MIL-H-17902F(SH)
AMENDMENT 1
12 December 1990

HOSE, END FITTINGS AND HOSE ASSEMBLIES,
SYNTHETIC RUBBER, AIRCRAFT FUELS

This amendment forms a part of MIL-H-17902F(SH), dated 23 December 1988, and is approved for use by the Department of the Navy and is available for use by all Departments and Agencies of the Department of Defense.

FIGURE 1. Hose and control wire assembly."

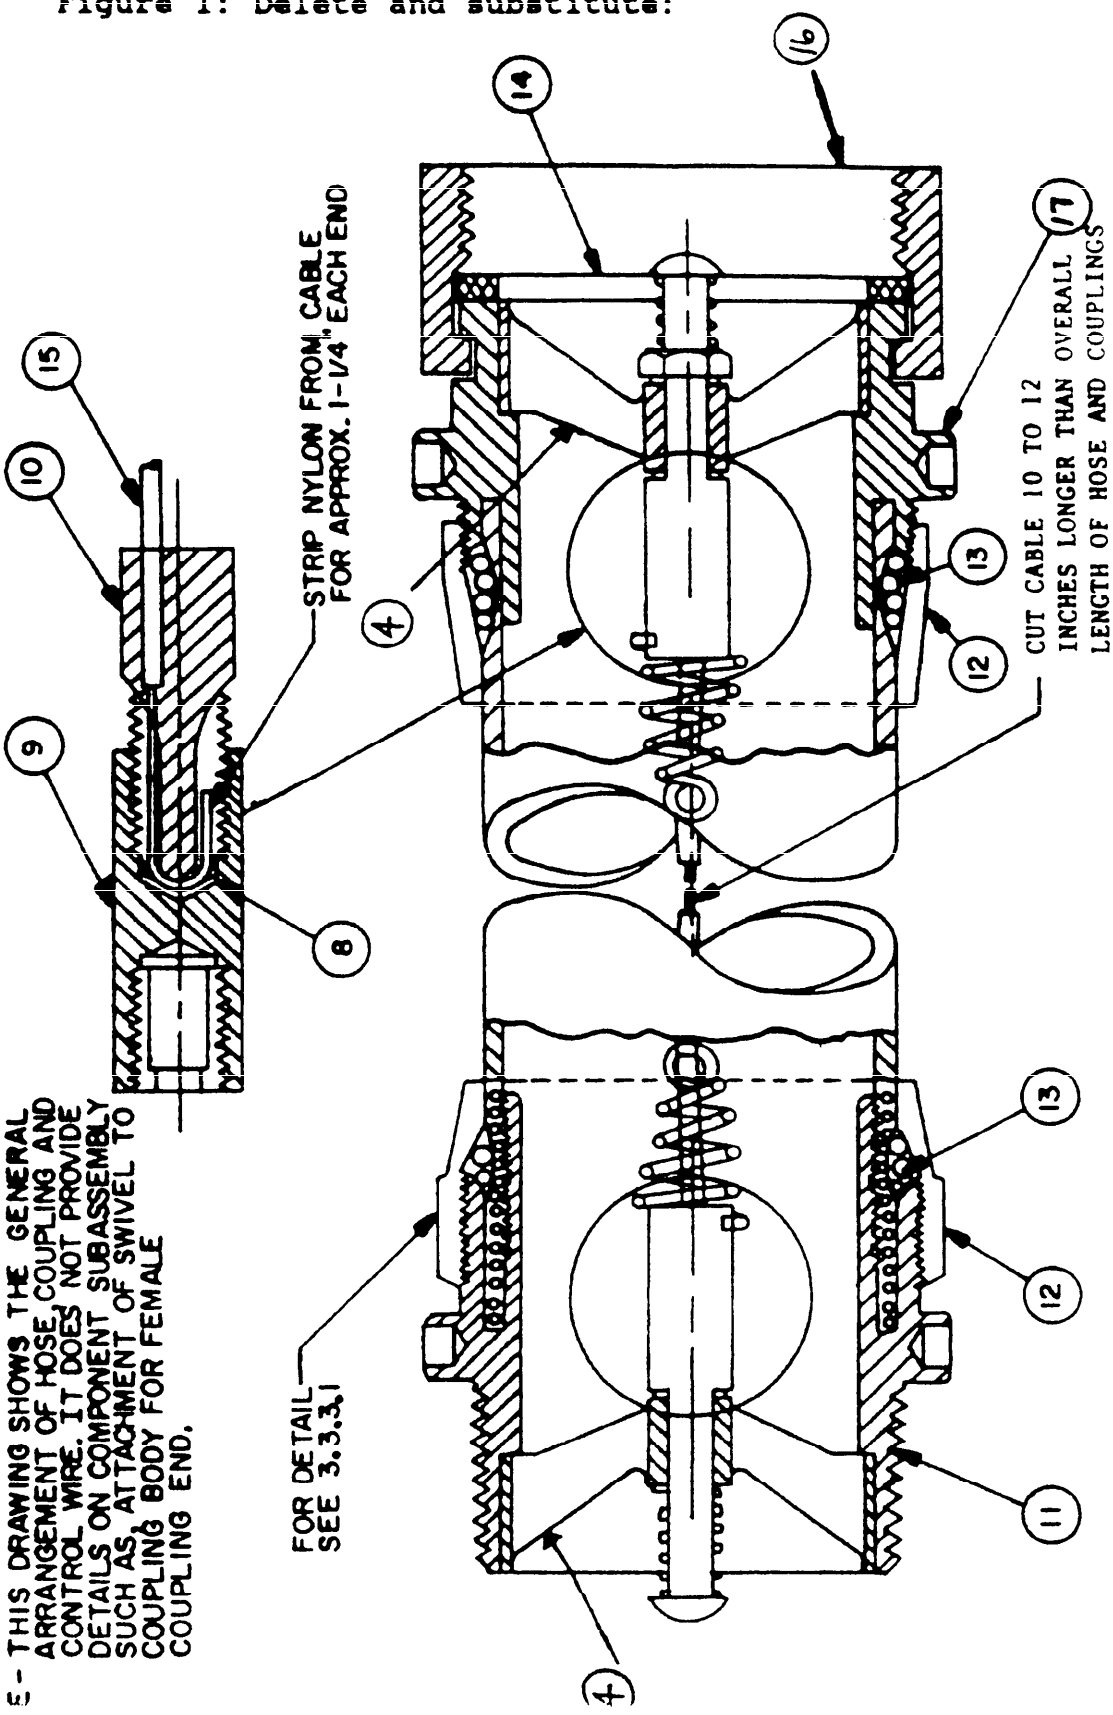
Figure 1: Delete and substitute:

E- THIS DRAWING SHOWS THE GENERAL ARRANGEMENT OF HOSE, COUPLING AND CONTROL WIRE. IT DOES NOT PROVIDE DETAILS ON COMPONENT SUBASSEMBLY SUCH AS, ATTACHMENT OF SWIVEL TO COUPLING BODY FOR FEMALE COUPLING END.

FIGURE 3. Partial detail of female coupling end."

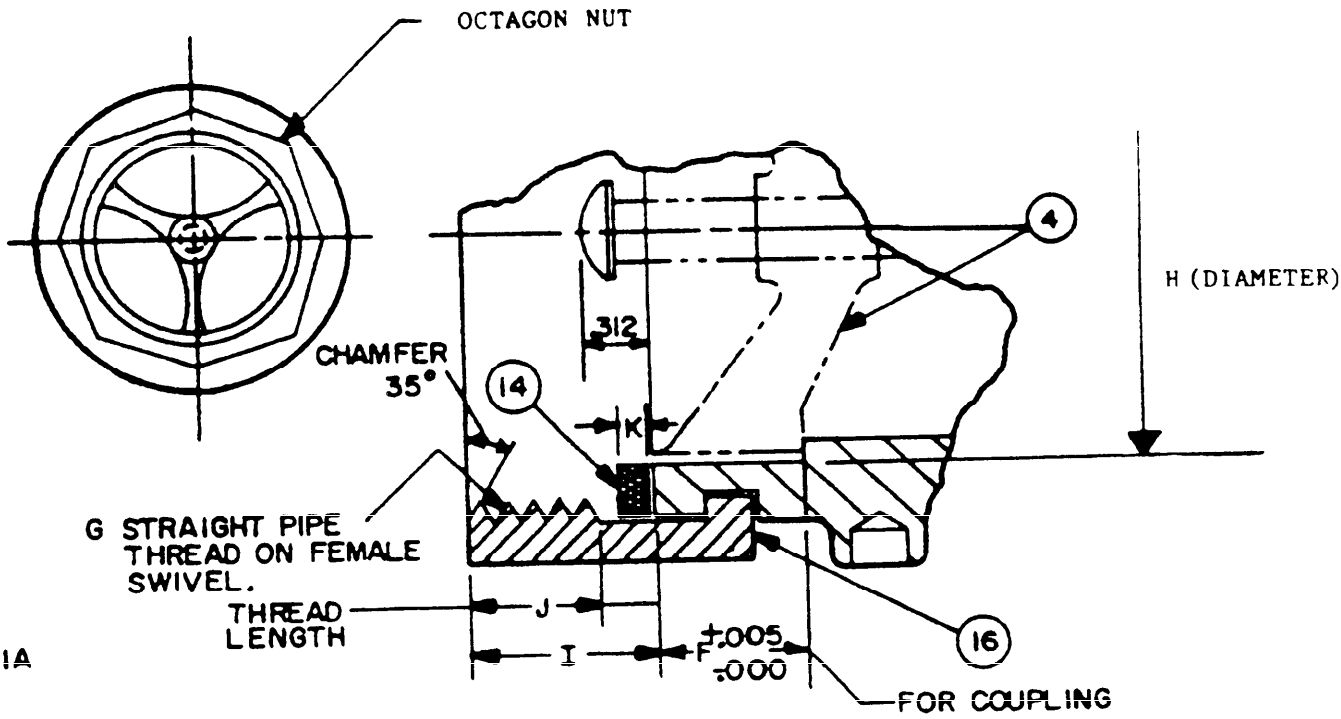
Figure 3: Delete and substitute:

SIZE	F	G	H	I	J	K
1-1/2	0.560	1-1/2 - 11-1/2 NPT	1.52	19/32	15/32	1/8
2-1/2	.781	2-1/2 - 8 NPT	2.52	15/16	11/16	3/16
